ADDENDUM NO. 2
HGTC CONSTRUCTION OF
GT WORKFORCE TRAINING CENTER
GEORGETOWN, SOUTH CAROLINA
STATE PROJECT NUMBER H59-6255-CB
PMH | CROFT PROJECT NO. 23041
September 15, 2025

THIS ADDENDUM CONTAINS:

- TWELVE (12) PAGES OF WRITTEN ADDENDUM
- FORTY-SIX (46) PAGES OF SPECIFICATIONS
- THREE (3) PAGE OF BULLETIN DRAWINGS
- TWELVE (12) FULL SIZE DRAWINGS

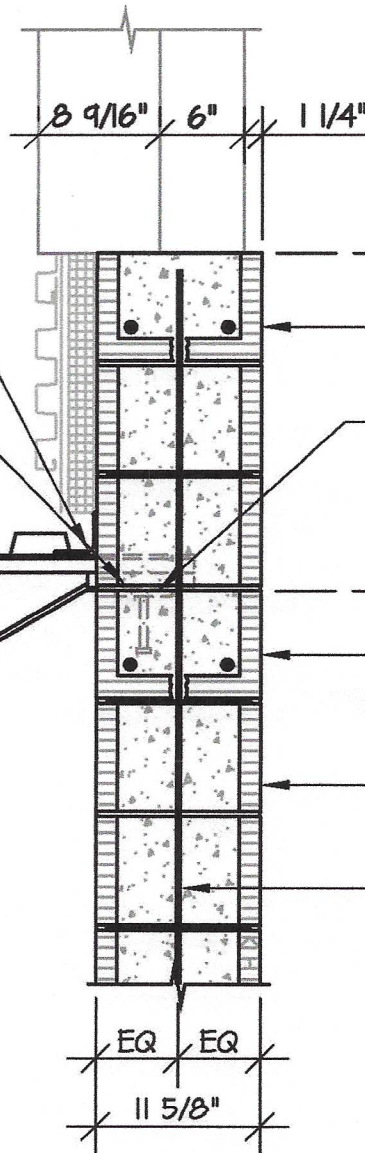
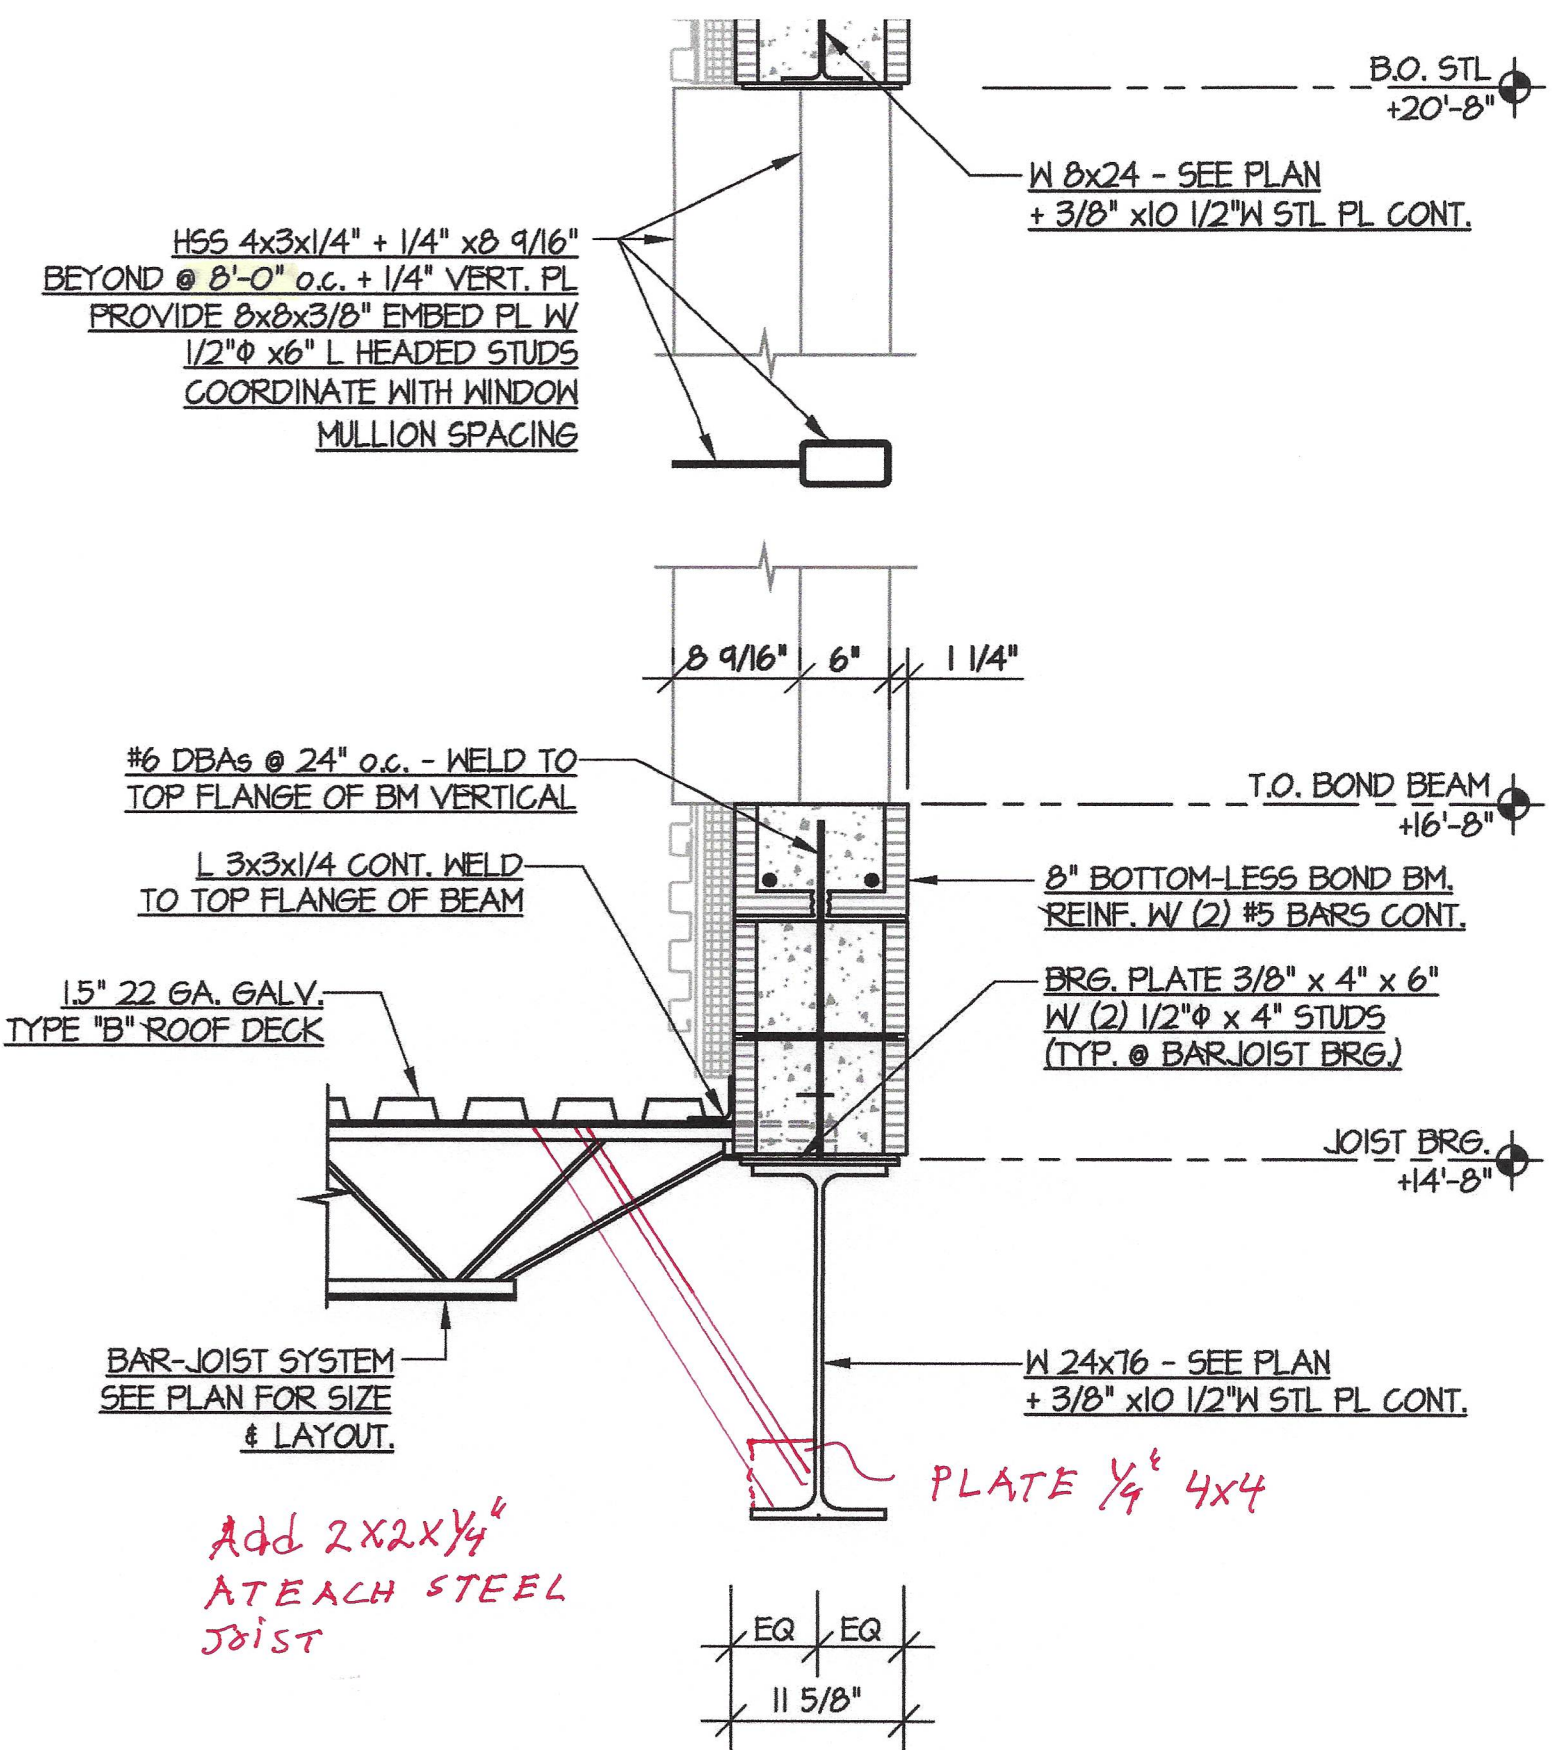
Q37. SECTION 6/S403 NOTES A W8X24 BEAM OVER THE 80' WIDE E12 STOREFRONT WINDOW AND REFERS TO THE PLAN. THE PLAN DOES NOT SHOW THIS BEAM. DOES THIS BEAM RUN THE ENTIRE 80' WIDTH OF THE WINDOW?

Q38. SECTION 2/S405 NOTES A W8X24 BEAM OVER THE 64' WIDE E11 STOREFRONT WINDOW AND REFERS TO THE PLAN. THE PLAN DOES NOT SHOW THIS BEAM. DOES THIS BEAM RUN THE ENTIRE 64' WIDTH OF THE WINDOW?

- A. Contractor's attention is directed to Bulletin Drawings (attached herewith) consisting of 3 pages with handwritten notes. For clarification, Contractor is advised to provide HSS 6x3x1/4" and associated steel at 8'-0" (not 16'-0") on center for sections 6/S402, 6/S403, and 2/S402.

- A. Contractor's attention is directed to Bulletin Drawings (attached herewith) consisting of 3 pages with handwritten notes. For clarification, Contractor is advised to provide HSS 6x3x1/4" and associated steel at 8'-0" (not 16'-0") on center for sections 6/S402, 6/S403, and 2/S402.

- A. Contractor's attention is directed to Bulletin Drawings (attached herewith) consisting of 3 pages with handwritten notes. For clarification, Contractor is advised to provide HSS 6x3x1/4" and associated steel at 8'-0" (not 16'-0") on center for sections 6/S402, 6/S403, and 2/S402.

SHEET NO.
L-101

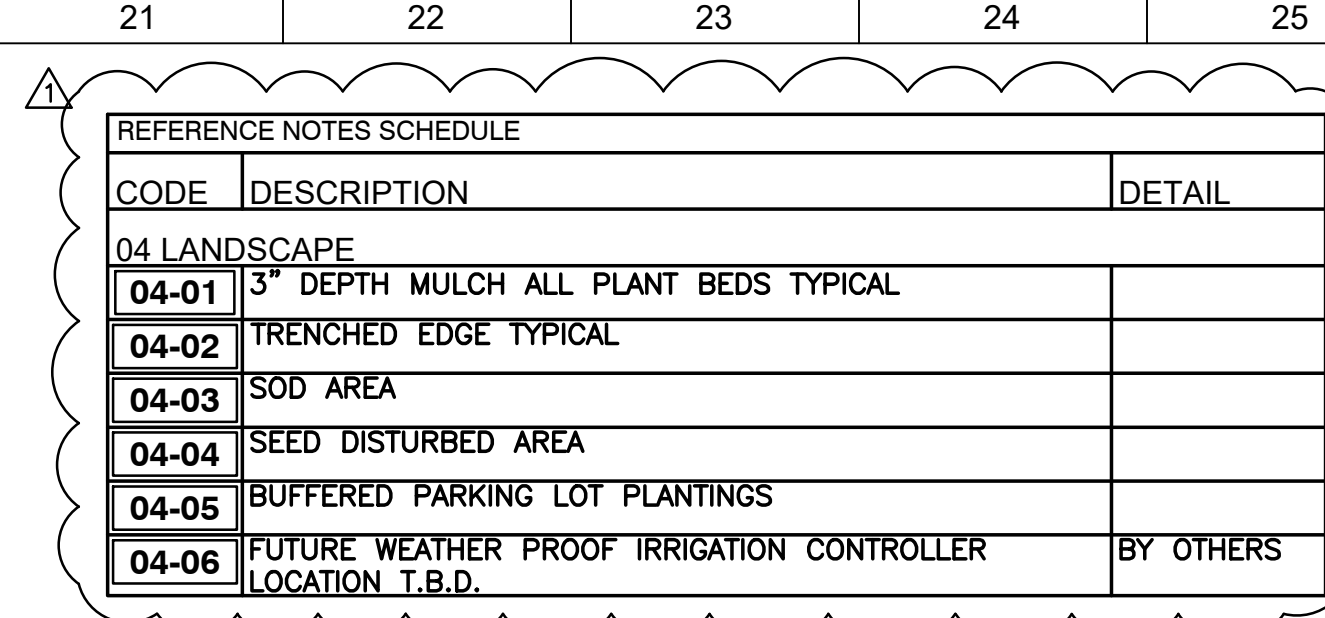
Q22. PLAN SHEETS L100, L101, & L200 HAVE NOTE LEADERS AND REFERENCE NOTES TABLES THAT ARE INCOMPLETE. PLEASE PROVIDE REVISED PLAN SHEETS.

A22. *Revised sheets L100, L101, L200 and L302 dated 09/10/2025 are attached.*

CAD DRAWING: Phoenix Aerating Fountain

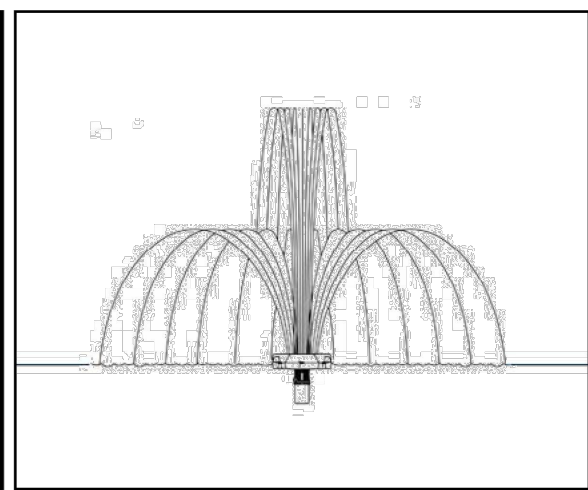
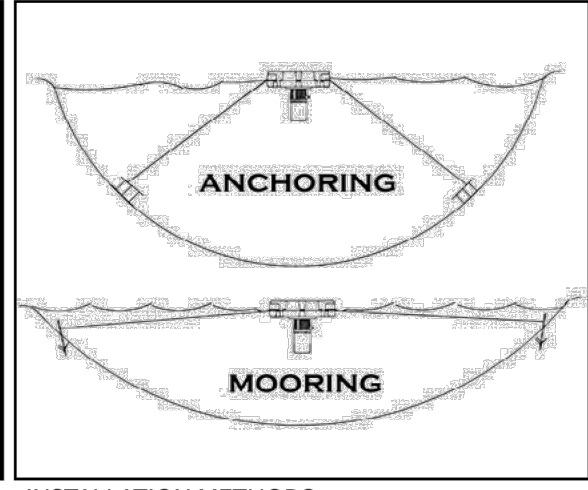
Q12. SHEET E080---WHO SUPPLIES AND INSTALLS THE AERATING FOUNTAIN CONTROL CENTERS

Q28. ARE THE FOUNTAINS/AERATORS SHOWN ON THE LANDSCAPING DRAWINGS PROVIDED BY THE GENERAL CONTRACTOR? IF SO, CAN YOU PLEASE PROVIDE A SPEC FOR THIS PRODUCT.

A12. *Contractor shall supply and install the Aerating Fountain System and Control Center. Manufacturer shall be Otterbine. Product: Phoenix Aerating Fountain. Model: 3HP 460V 3PH 60 HZ. See revised Sheet L302 dated 09/10/2025 attached.*

1 ELECTRICAL SITE PLAN
E080 SCALE: 1" = 30'-0"

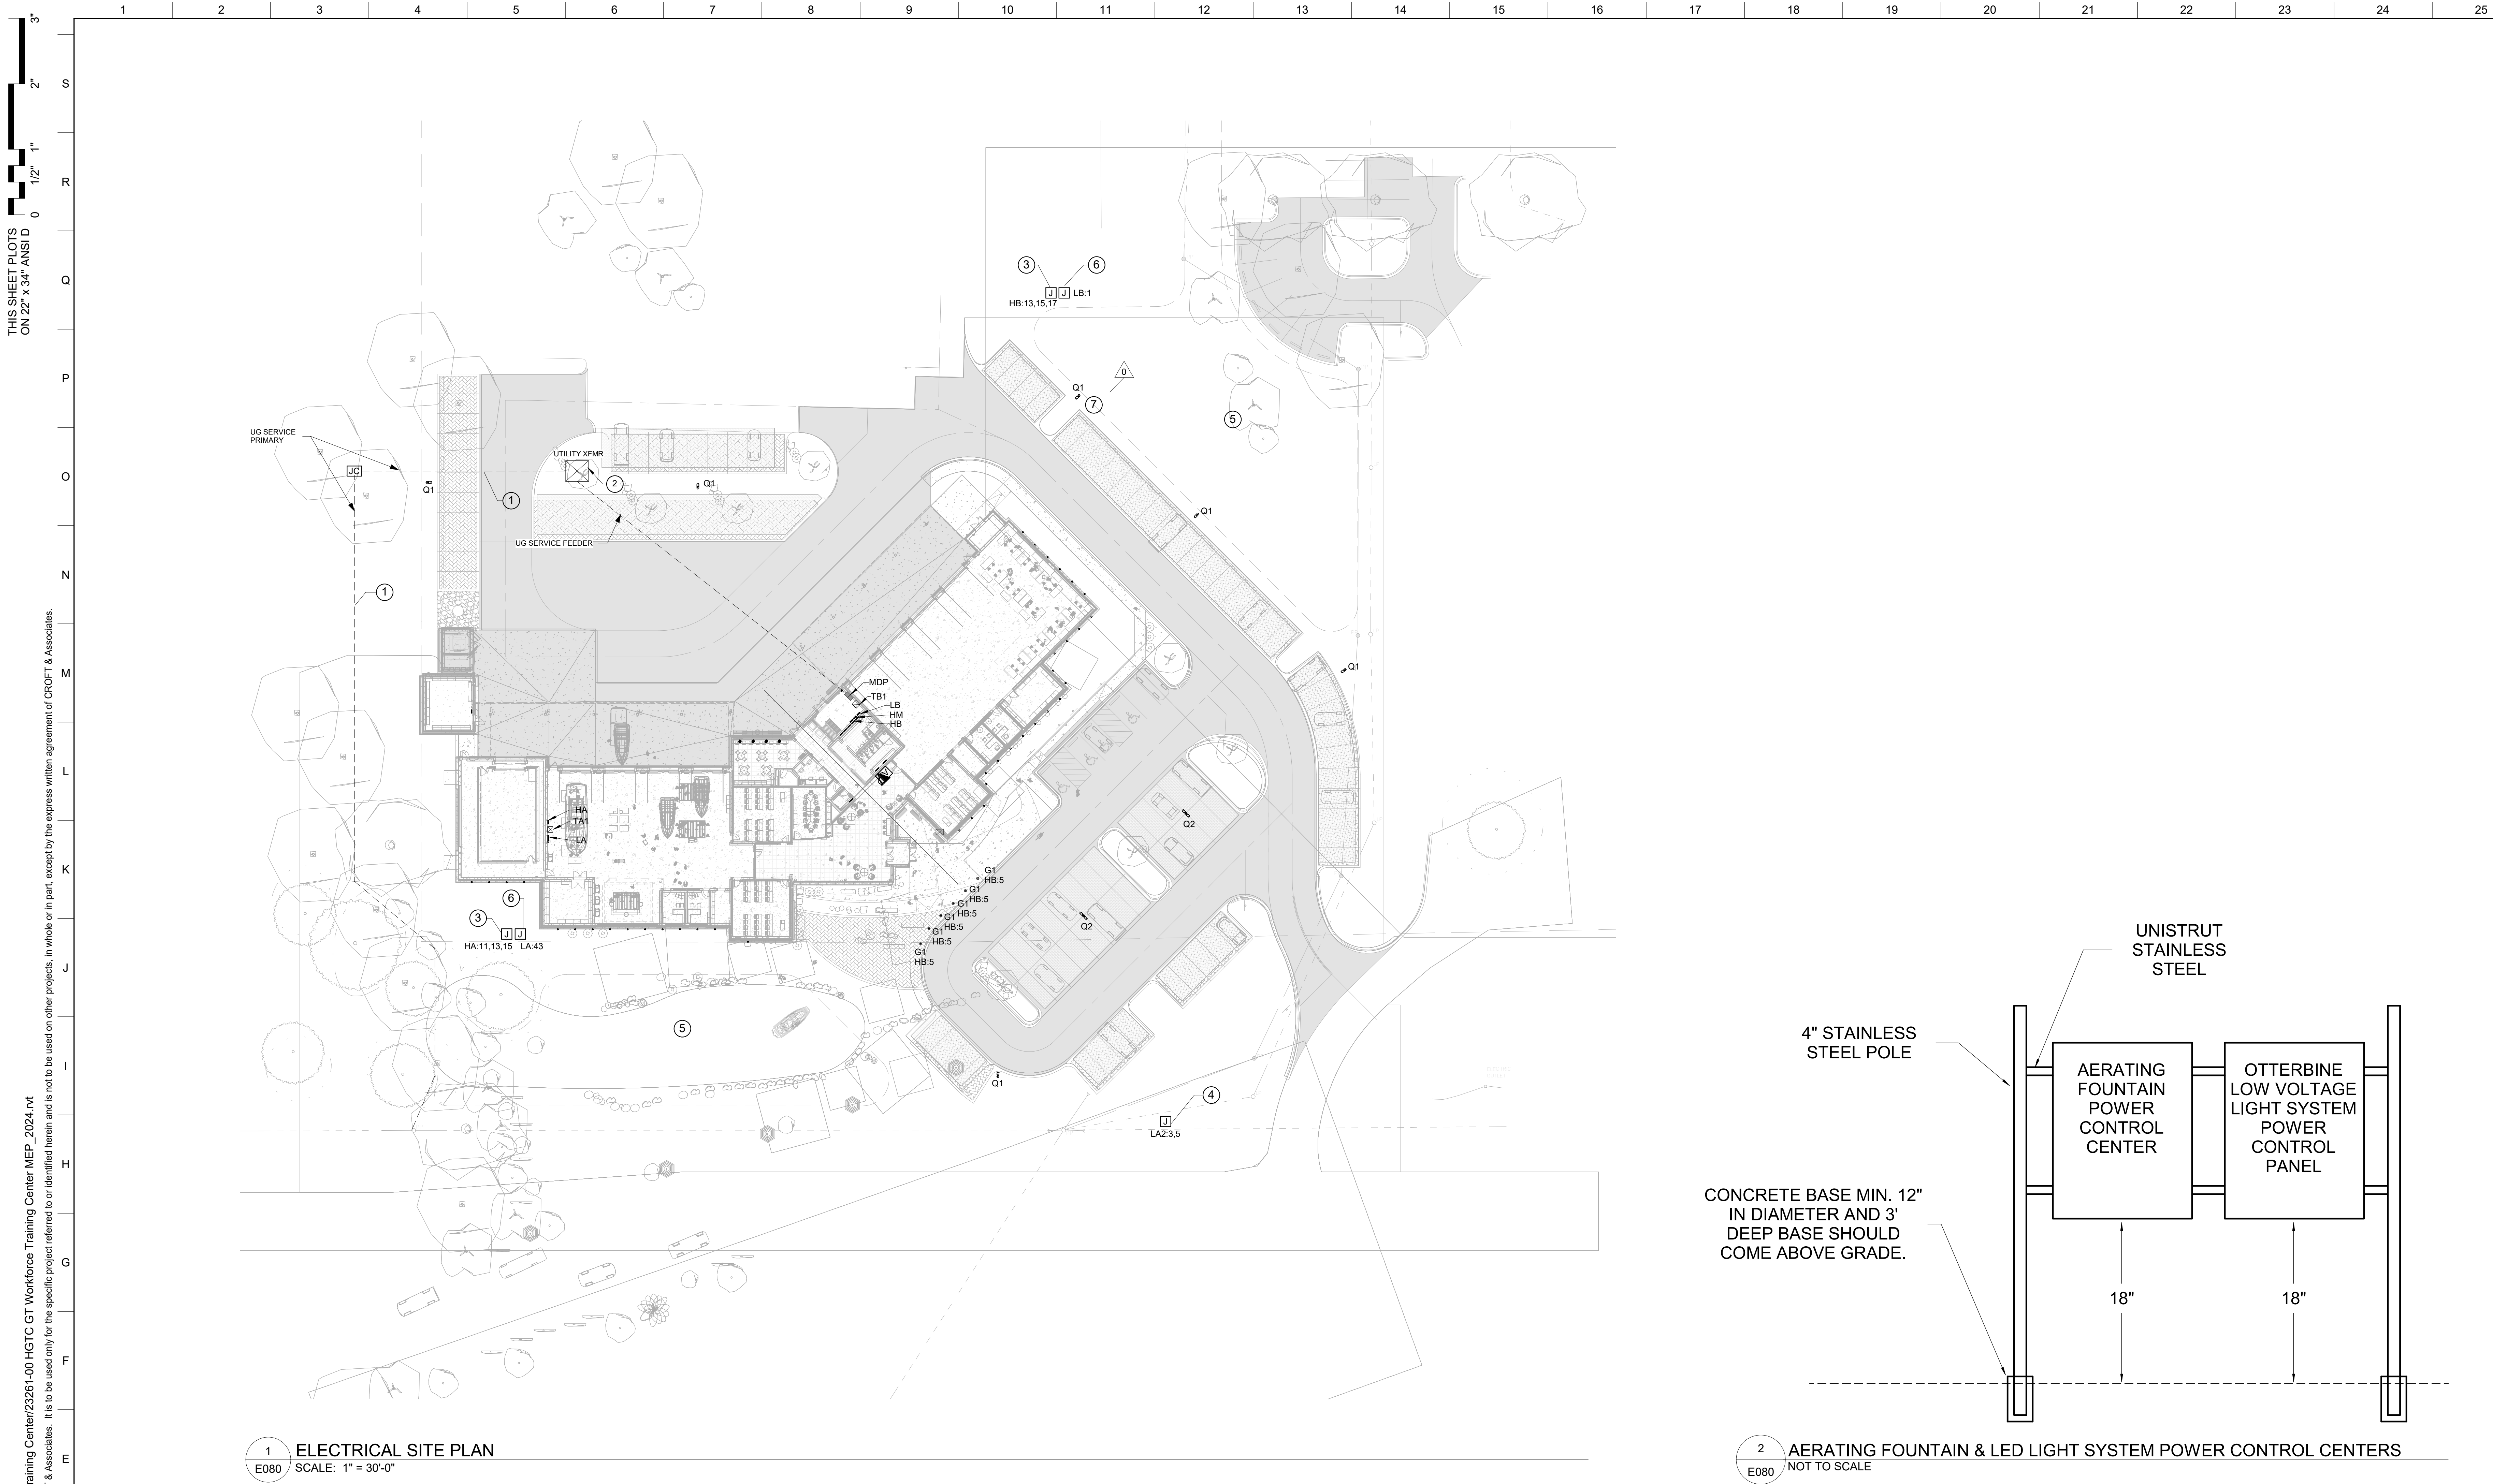
Q14. SHEET E080---WHAT ARE THE CONDUIT REQUIREMENTS FROM THE FOUNTAIN CONTROL EQUIPMENT OUT TO THE PONDS.

Q15. SHEET E080---EQUIPMENT STAND DETAIL IS CALLING FOR 4" STAINLESS STEEL UPRIGHTS, THIS TYPE OF CONDUIT IS EXTREMELY EXPENSIVE. COULD WE SUGGEST STANDARD GALVANIZED RIGID CONDUIT FOR THESE UPRIGHTS?

- A. Contractor's attention is directed to SHEET E080 – ELECTRICAL SITE PLAN. Contractor is advised to omit this sheet in its entirety and replace with SHEET E080 – ELECTRICAL SITE PLAN (attached herewith) dated 9/9/25 and consisting of 1 page for the renovations Keynote (3) revised to coordinate exact location and specification with landscape plans.
